Subject: FINAL ENVIRONMENTAL ASSESSMENT FOR THE
GAC TREATMENT FACILITY AT NAPILI WELL "A"
NAPILI, MAUI, HAWAII (TMK 4-3-01:06)

FINAL ENVIRONMENTAL ASSESSMENT
FOR THE
GAC TREATMENT FACILITY AT NAPILI WELL "A"
NAPILI, MAUI, HAWAII
(TMK: 4-3-01: 06)

Subject: **RESPONSE TO COMMENTS ON THE DRAFT ENVIRONMENTAL
ASSESSMENT FOR THE GAC TREATMENT FACILITY AT NAPILI
WELL "A"**
NAPILI, MAUI, HAWAII **TMK 4-3-02:006**

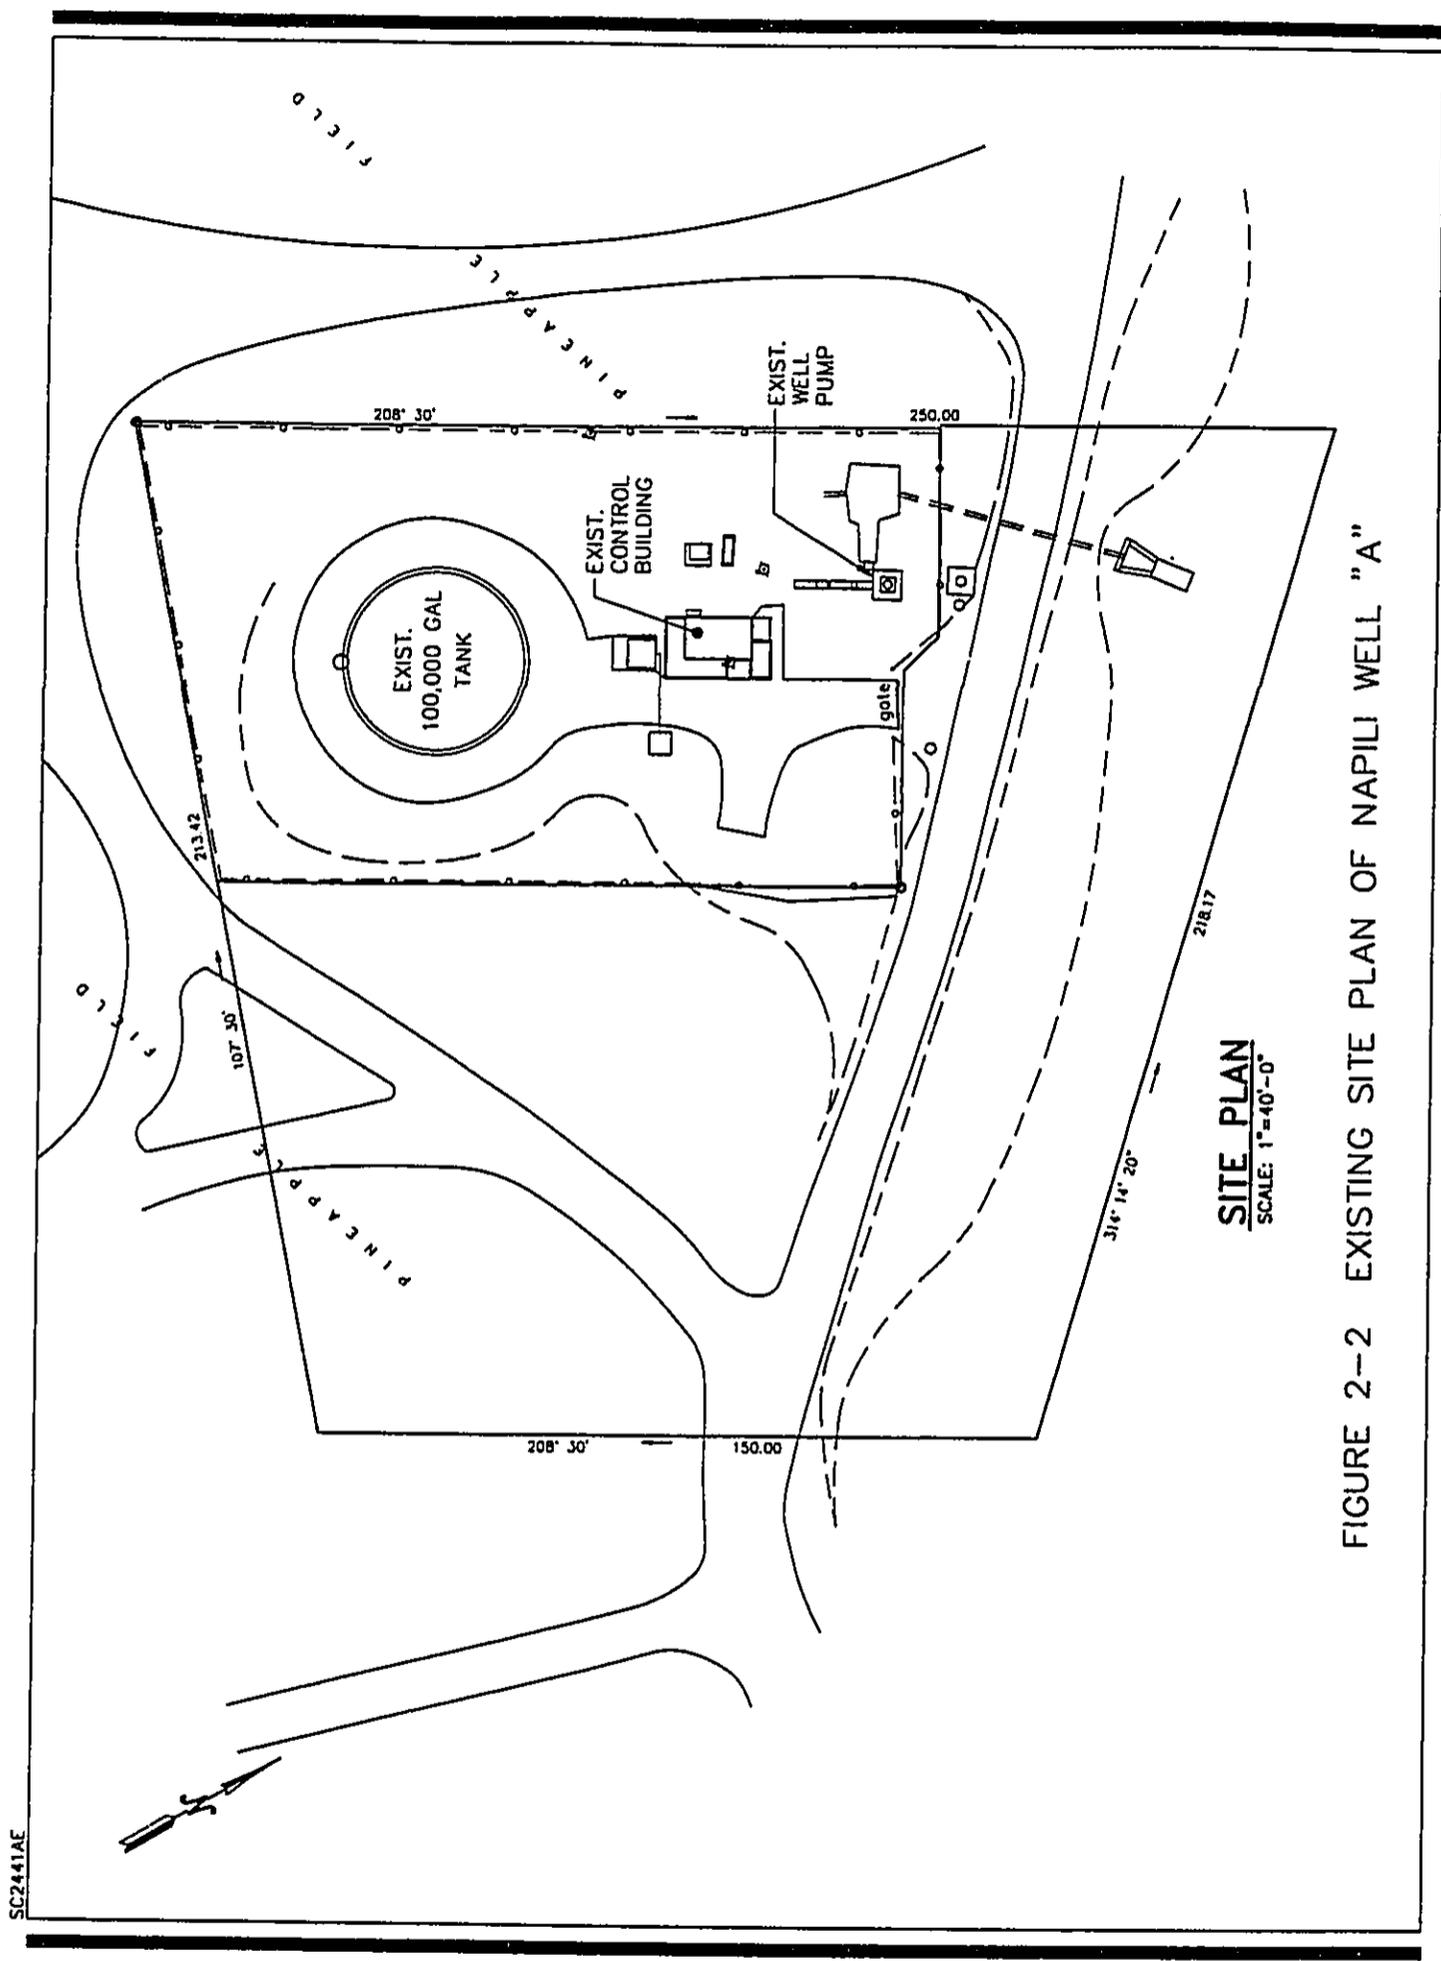
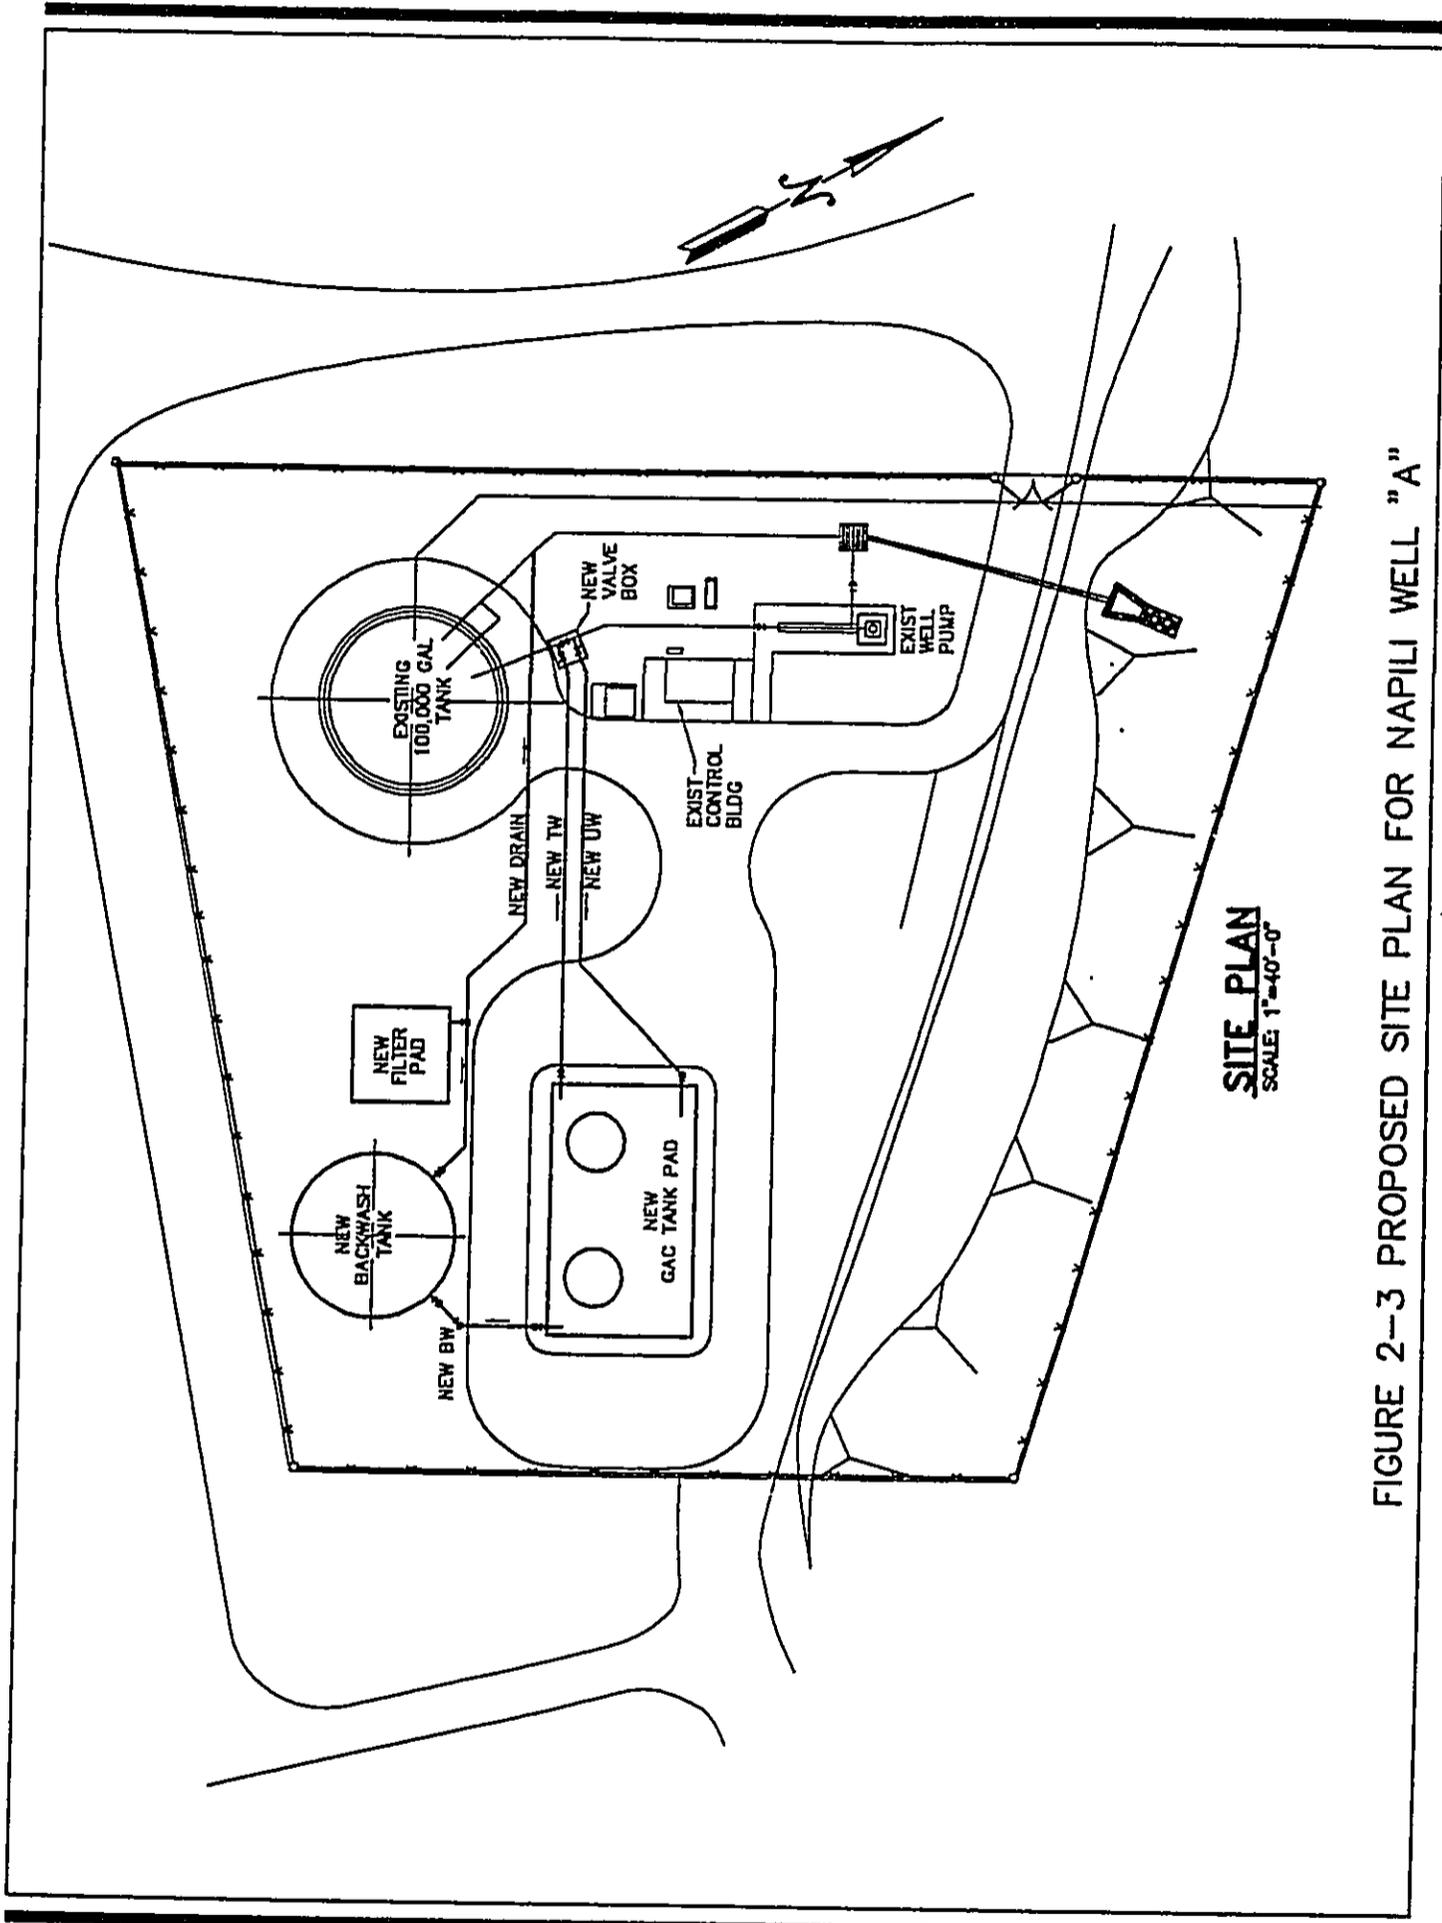
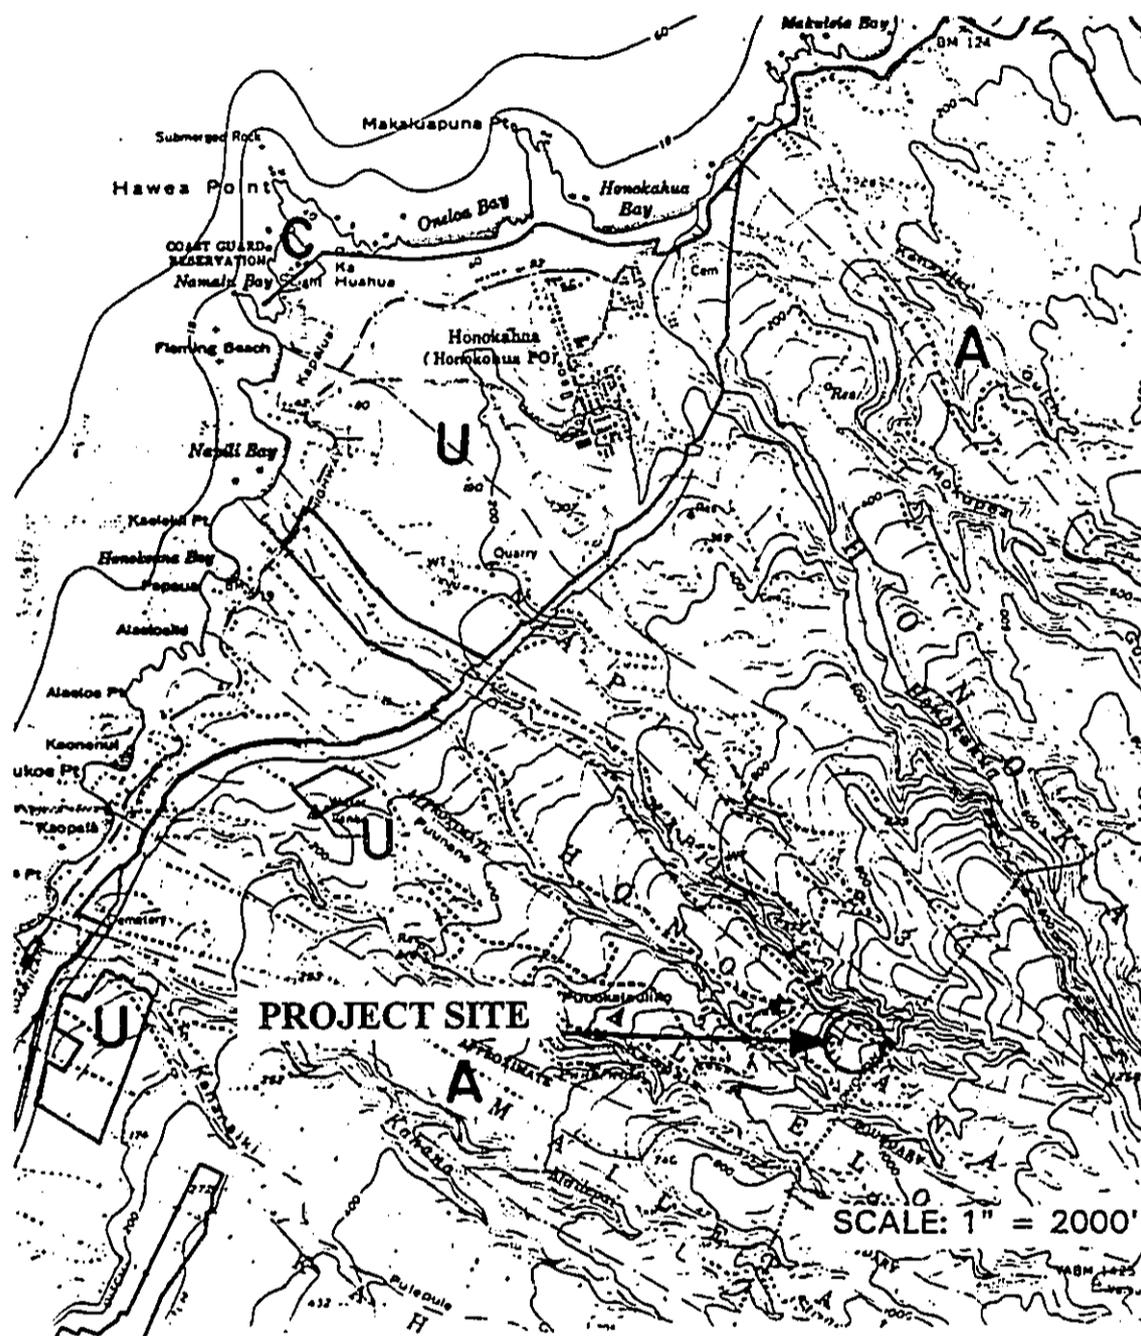
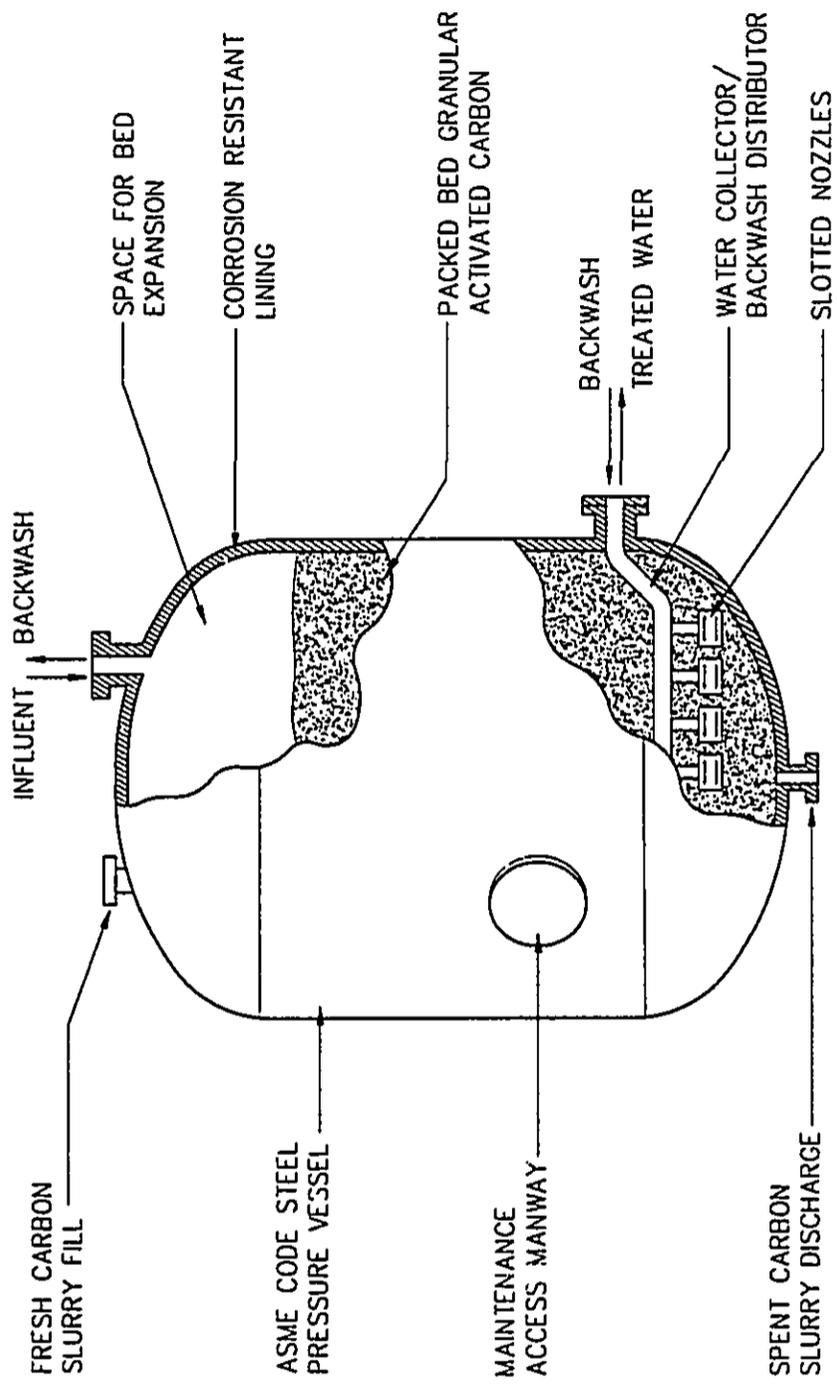
COMMENT: "The copy of the report we received has two instances where text is repeated on sequential pages (pp2-2/2-5, 2-8/2-9) and one where text is missing (the transition between pp 2-7/2-8). All the Figures should have a scale or other dimensioning to allow better understanding (i.e. Figures 2-1, 2-2, 2-3, 3-1, 3-2, 5-1 and 5-2).

RESPONSE: The text on pages 2-2/2-5, 2-8/2-9, and 2-7/2-8 has been corrected. Figures 2-1, 2-2, 2-3, 3-1, 3-2, 5-1 and 5-2 have been edited to include a scale.
